REMARKS

Applicant hereby responds to the Office Action of Jan. 18, 2005, in the above-referenced patent application. Before this Amendment, Claims 1-20 were pending in the above-referenced patent application. Through this Amendment, Claims 21-32 have been added, such that Claims 1-32 are now pending in the patent application. No new matter has been added.

Figure 3

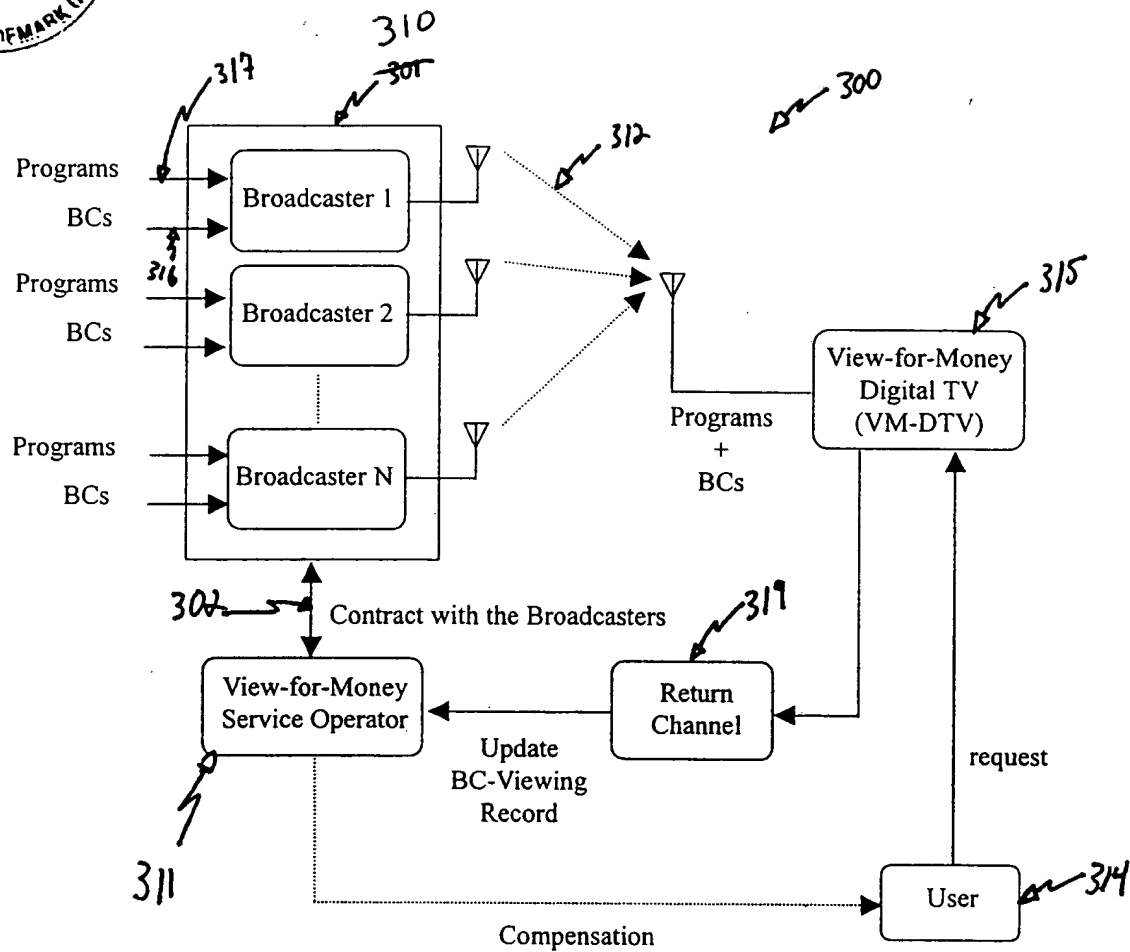
In Fig. 3, reference character "301" has been corrected to "310". In Fig. 4, reference character "429" has been added, reference character "417" has been added and reference character "430" has been corrected. In Fig. 8, reference character "800" has been added.
